VIRGINIA ELECTRIC AND POWER COMPANY (DOMINION)
NORTH ANNA POWER STATION UNITS 1 AND 2
PROPOSED TECHNICAL SPECIFICATIONS CHANGES AND EXEMPTION
REQUEST FOR USE OF FRAMATOME ANP ADVANCED MARK-BW FUEL
SUPPLEMENTAL INFORMATION FOR REALISTIC LARGE BREAK LOSS OF
COOLANT ACCIDENT (RLBLOCA) CONTAINMENT MODEL

**Supplemental Response to Request for Additional Information
Containment Response Model Comparison from
November 10, 2003 letter (Serial No. 03-313G)**

Dominion Supplemental Response to NRC Request for Additional Information
North Anna Realistic LBLOCA Analysis
Containment Response Model Comparison of
November 10, 2003 letter (Serial No. 03-313G)

Figure 1 North Anna RLBLOCA Guideline Containment Model Qualification Comparison

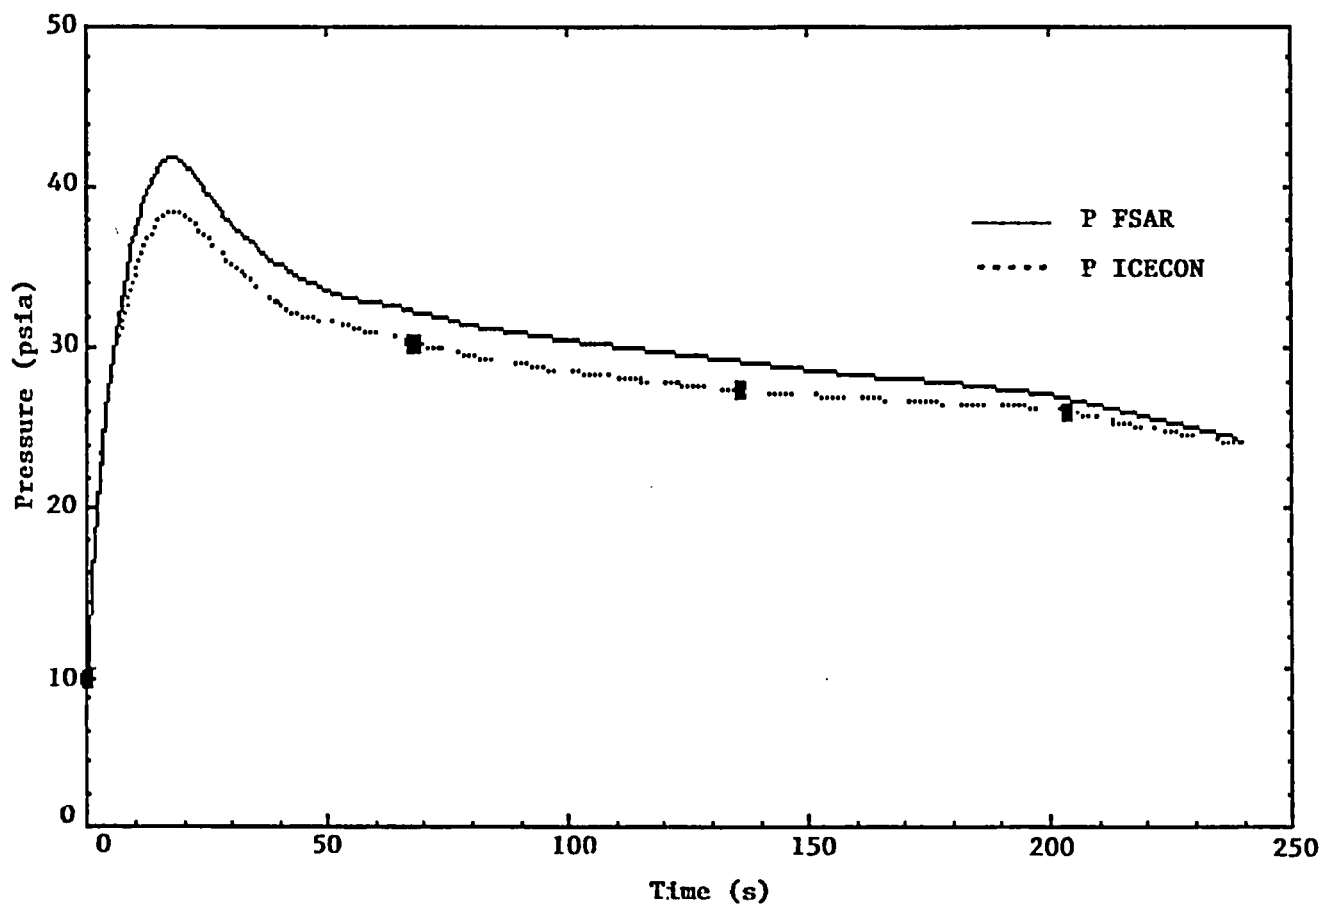
Letter 03-313G mentioned containment response simulations comparing results from the S-RELAP5 model with CSB 6-1 inputs and the existing UFSAR minimum containment response simulation. Please provide a figure that documents this comparison, as discussed in the November 25, 2003 telephone conference call.

"The 1.7 multiplier was validated for the North Anna analyses by demonstrating good (less than one psi tolerance) or bounding agreement between simulations using S-RELAP5 with CSB 6-1 inputs and the existing UFSAR minimum containment response simulation."

To establish confidence in the plant-specific ICECON containment model, the Framatome ANP RLBLOCA guidelines require performing a benchmark calculation for comparison with an existing minimum containment back pressure calculation. Figure 1 presents the result from the required calculation. It compares results of the North Anna UFSAR Appendix K minimum containment backpressure calculation (solid line) with a North Anna ICECON containment backpressure calculation (dotted line). The ICECON calculation was performed for the same break size as the existing UFSAR case. The mass and energy releases used in the ICECON simulation were generated by S-RELAP. The results of this calculation established qualification for the ICECON model, which was then subsequently used in accordance with the approved methodology of EMF-2103.
